**Development Permit Panel
Electronic Meeting**

1. DEVELOPMENT PERMIT 23-025993
(REDMS No. 7412868)

PROPERTY LOCATION: 4831 Steveston Highway

1. DEVELOPMENT PERMIT 18-829236
(REDMS No. 7427015)

Tree #726

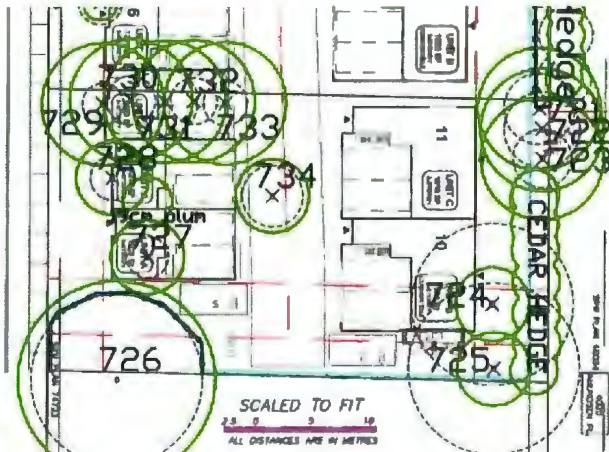
Tree #726 and the concrete retaining walls surrounding the tree well.

Tree #726 as viewed along both sides of the south property line.

Tree health and recommendation to remove

Landscape redesigned at SW corner (top: plan details, bottom: partial site sections)

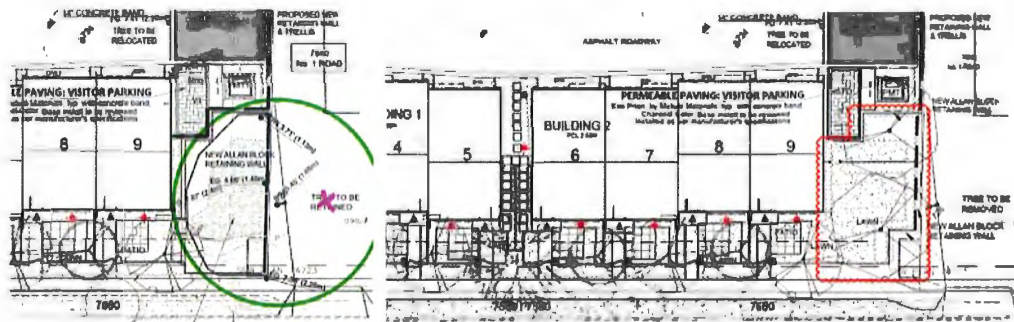
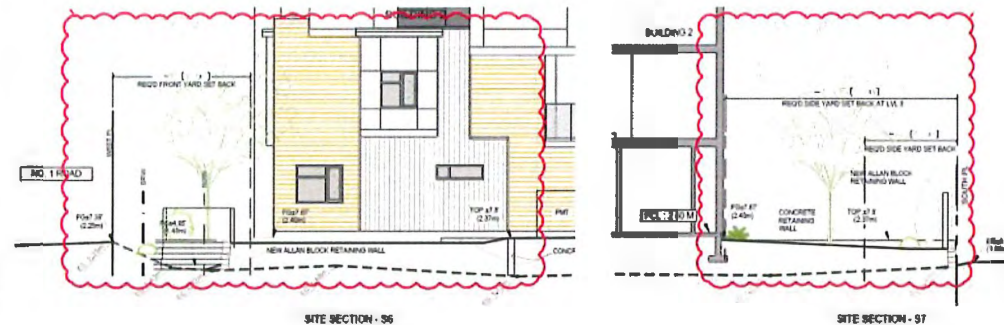
The revised landscape DP drawings incorporates 3 factors (*landscape architect text in italics*):

1. Leaves intact the cast-in-place concrete retaining walls that are already constructed.
Even though the grade will be raised in front of these walls, they will be defining & retaining the adjacent visitor parking space and a PMT kiosk.

2. Replaces the one dead Sycamore Maple with 2 Fastigate or Dawyck Beech trees per bylaw.
"We are proposing two replacement trees for the removed #726 per City's Schedule A to Bylaw No. 8057. Type and location of the proposed replacement trees is consistent with the existing conditions and provides better privacy screening from neighboring development."

3. Raises the grade, adds shrubbery, and adds a retaining wall at the south PL.
"Proposed updated landscape design accordingly removed existing tree leads to improved design for south-east corner of private yard for Unit 9 - giving more usable space, increasing open lawn area, and raising the proposed grade. Proposed shrubs and grasses are proposed at building façade and fence line and provide privacy from neighboring site and PMT & visitor parking spot next to internal driveway South end. Allan block allows construction flexibility if the south neighbor develops in the future."

Environmentally Sensitive Areas

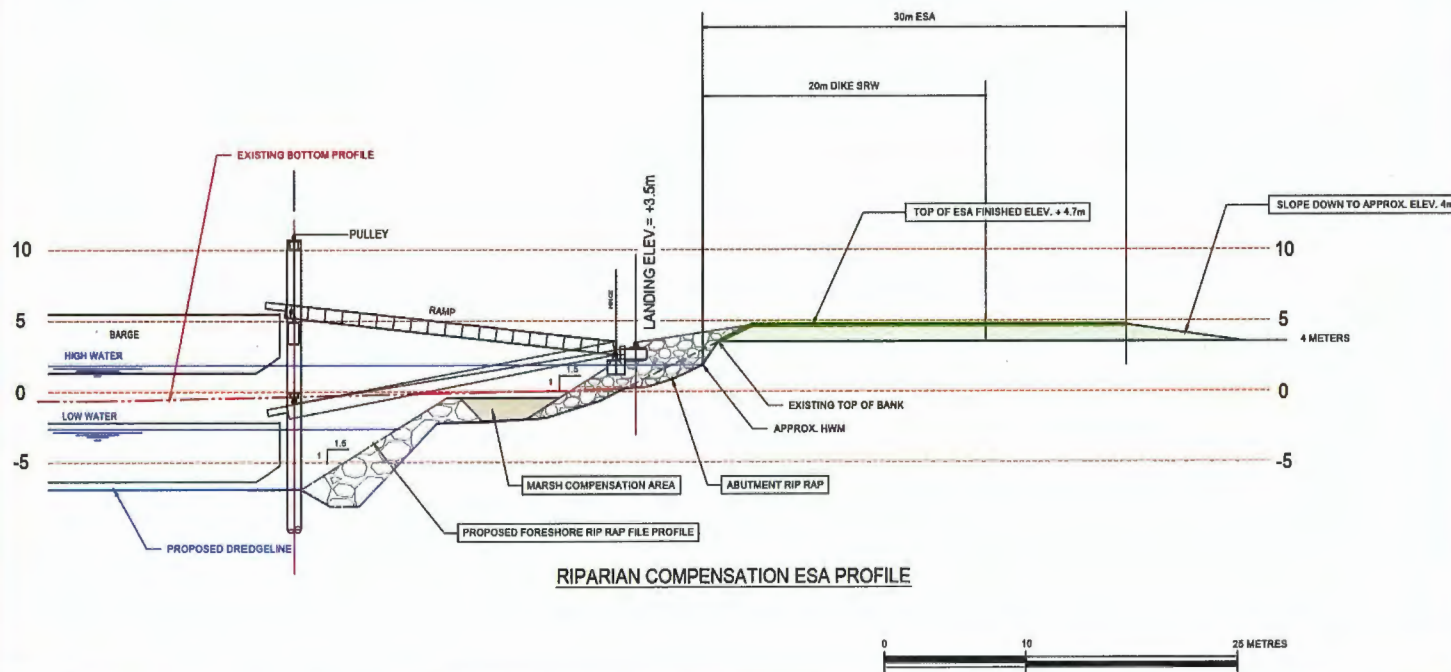
The habitat compensation ratio (1.4 : 1) will result in a net gain of **245 m²** of high-value habitat once works are complete and the vegetation is well established.
